Panel Reference	PPSSNH-625
DA Number	eDA0157/25
LGA	Ku-ring-gai
Proposed Development	Demolition of existing structures, lot amalgamation and construction of a residential flat building with basement parking
Street Address	23-25 Lorne Avenue, Killara
Applicant/Owner	Applicant: BWSLD Killara II Pty Ltd Owner: Sld Developments Twelve Pty Ltd, Bridgewell Killara Li Pty Ltd, Deltakap Ventures Pty Ltd, Kim H Dinh
Date of DA lodgement	17 April 2025
Total number of Submissions	119
Number of Unique Objections	>10
Recommendation	Refusal
Regional Development Criteria Schedule 6 of the SEPP (Planning Systems) 2021	Estimated development cost of greater than \$30 million
List of all relevant s4.15(1)(a) matters	• Environmental Planning and Assessment Act 1979 • Environmental Planning and Assessment Regulation 2021 • Environmental Planning and Assessment (Savings, Transitional and Other Provisions) Regulation 2017 • State Environmental Planning Policy (Resilience and Hazards) 2021 • State Environmental Planning Policy (Biodiversity and Conservation) 2021 • State Environmental Planning Policy (Sustainable Buildings) 2022 • State Environmental Planning Policy (Transport and Infrastructure) 2021 • S

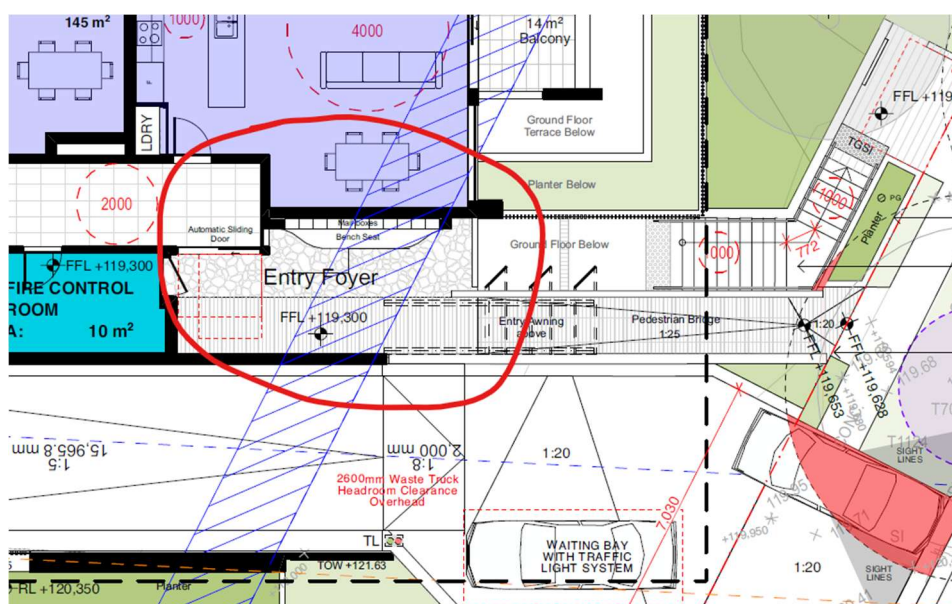
Also, the entry ramp and the ramps connecting the basement levels have gradients of up to 1:4 (20%), which generally will exceed the capability of many bicycle users to remain mounted with stability (1:12, or 8% is practical). Bicycles are also unlikely to trigger the proposed traffic signal control system managing the ramp access. Therefore, the lifts and lobbies should be of a suitable size such that residents can transport their bicycles between their storage area and ground/street level without using the internal car park ramps.

Visitor bicycle parking appears to be located on the Lower Ground floor, next to the AC Units room. Similar ramp gradient accessibility issue to residents arise (as noted above), and given the additional practicality of visitors entering the secure parking area to access the bicycle parking from the main entry ramp, it is recommended that the visitor bicycle parking be relocated to somewhere near the Entry Foyer, in accordance with AS2890.3 (circled in red):

Figure 8: Extract Architectural analysis Future Character prepared by the applicant based on TOD policies.

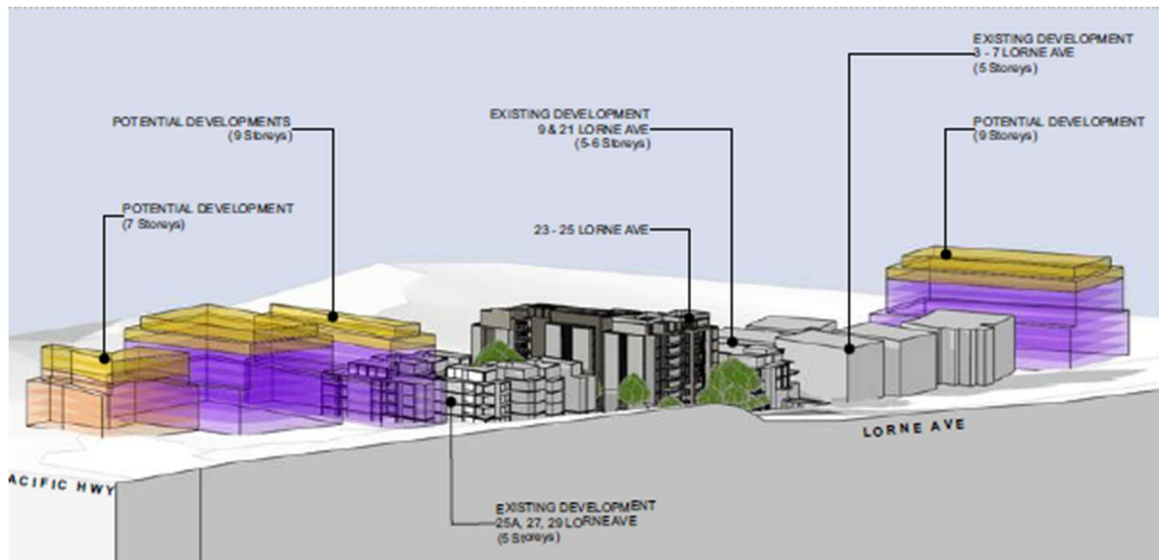
- c) The architectural analysis prepared by BKA Architecture (Figure 8) describes the proposed development in the context of existing and future development. Future developments have been extrapolated by the applicant to show future TOD developments based on the TOD controls pursuant to SEPP Housing rather than the TOD Alternative Scheme, so this is not reflective of the future character of the area.

- d) The proposal fails to achieve consistency with the desired future character because:
- i) The site is surrounded by R4 High Density, R2 low density zones and the HCA. Under the proposed TOD Alternative Scheme, the adjoining sites to the south retain their R2 zoning, and HCA / heritage item status, in order to retain and maintain the character and low density scale on the southern side of Lorne Avenue. As such, the Site abuts a zone interface to the south.
